UNITED STATES PATENT AND TRADEMARK OFFICE

Office Action Summary

09/601,545

BREYNAERT, FRANCOIS

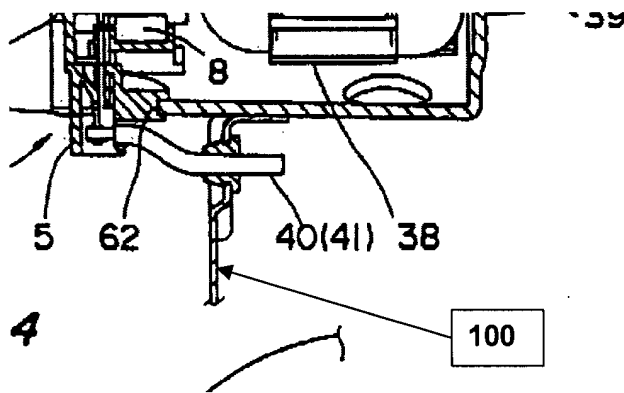
7. Takiguchi clearly teaches the construction of a noise suppression system for a permanent-magnet motor (1), in which:

the motor includes supply brushes (26, 27) connected to an external power supply by leads (40, 41), which are associated with inductors (6, 7);

and a metal casing (5), characterized in that:

each brush is connected to the metal casing of the motor through at least one noise suppression capacitor (8),

in that the metal casing of the motor is connected to the vehicle's earth, and

that the metal casing of the motor and the functional device have complementary means (100, added by the examiner) for earthing the casing.

8. With regards to claim 4, Takiguchi disclose a permanent magnet motor wherein the means for earthing the casing of the motor comprise means (100) for fastening this motor to the functional device.
